**Issues relating to the Globally Harmonized System
of Classification and Labelling of Chemicals:
Classification criteria for flammable gases**

**Classification criteria for flammable gases – comments on
informal document INF.15 (TDG, 48th session) – INF.4
(GHS, 30th session)**

**Transmitted by the expert from Germany, the European Industrial
Gases Association (EIGA) and the European Chemical Industry
Council (CEFIC)**

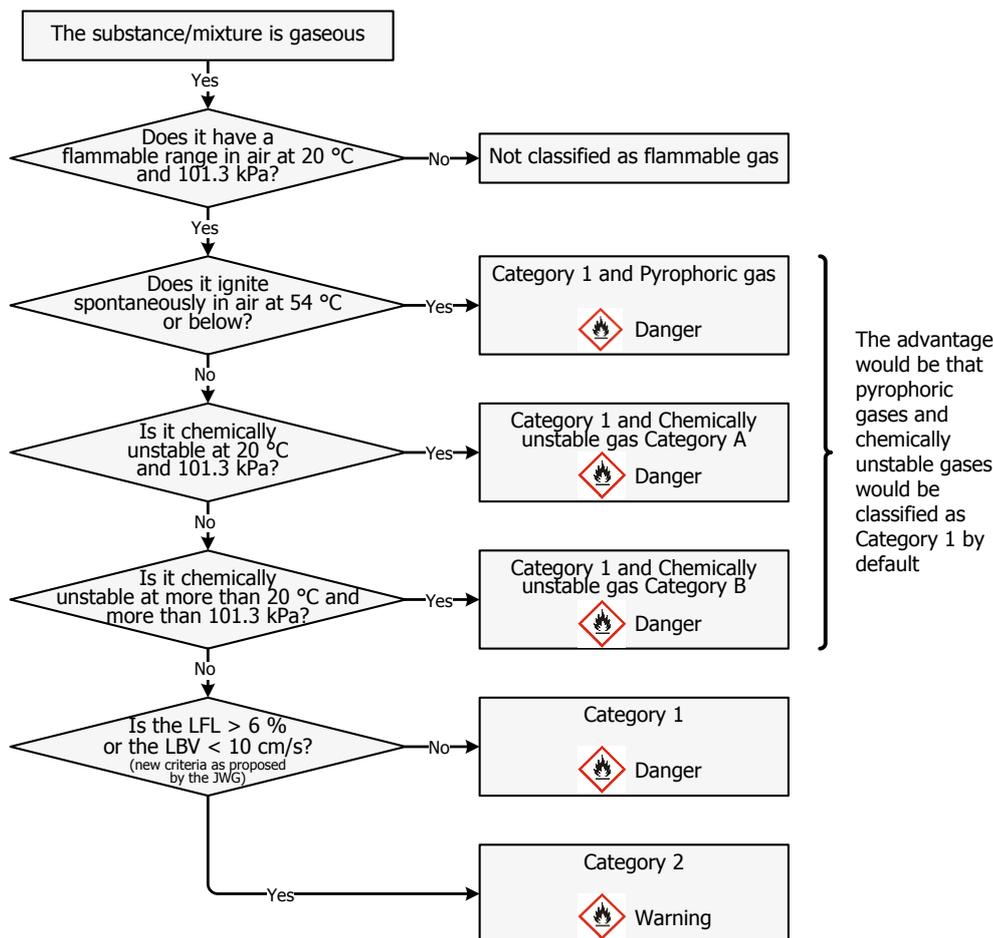
9. The alternative proposal in principle is the same as contained in informal document INF.15 (TDG, 48th session) – INF.4 (GHS, 30th session) of the IWG except that the old (and virtually empty) category 2 is used instead of creating a new sub-category 1B. It is based on the same criteria as proposed by the IWG. The principle is that all flammable gases are assigned to the new GHS category 1, but they may be moved to category 2 if they have a LFL > 6 % by volume or a laminar burning velocity, LBV < 10 cm/s as shown in the following figure:

10. This would allow to make good use of category 2:

- (a) instead of further sub-dividing category 1,
- (b) while keeping an old, virtually empty category 2 at the same time, which once was created based on data which are outdated nowadays,
- (c) thus avoiding further complication of the hazard class flammable gases which is already rather complicated because it contains supplemental categories for pyrophoric gases and chemically unstable gases.

11. In addition, appropriate hazard communication for the new GHS category 2 could be considered and a pictogram (symbol flame) could be assigned also to this new category 2.

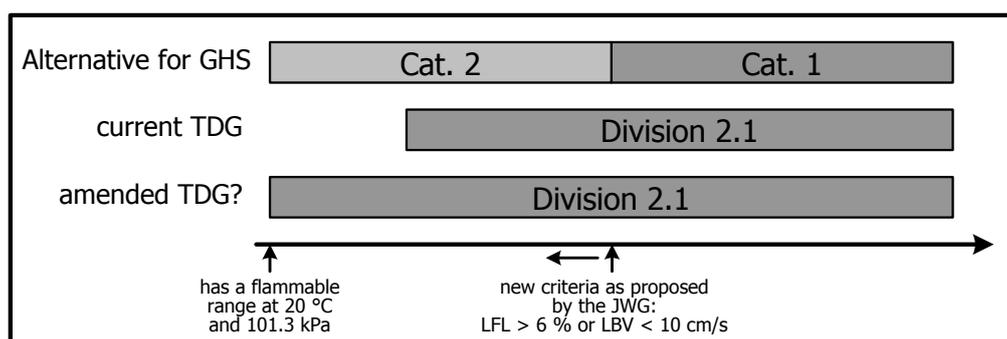
17. In order not to lower the level of protection, TDG division 2.1 could be extended. Division 2.1 then would cover all gases having a flammable range (i.e. all flammable gases as defined in the GHS) as shown in the following figure:

18. This would be in line with the principles for explosion protection world-wide: Any gas mixture having a flammable range in air might cause problems in case of a leakage or an accident, not only in supply and use but also during transport. Drivers and rescue personnel etc. should be aware about flammable properties in order to take appropriate measures, avoid ignition sources etc. GHS and TDG then would be harmonized for flammable gases.

19. The formal consequences in the UN Recommendations on the Transport of Dangerous Goods would be limited to the deletion of a few words in section 2.2.2.1 (a) as follows:

(a) Division 2.1 Flammable gases
Gases which at 20 °C and a standard pressure of 101.3 kPa:
~~(i) are ignitable when in a mixture of 13 per cent or less by volume with air; or~~
~~(ii) have a flammable range with air of at least 12 percentage points regardless of the lower flammable limit.~~
Flammability shall be determined by tests or by calculation in accordance with methods adopted by ISO (see ISO 10156:2010). Where insufficient data are available to use these methods, tests by a comparable method recognized by a national competent authority may be used;
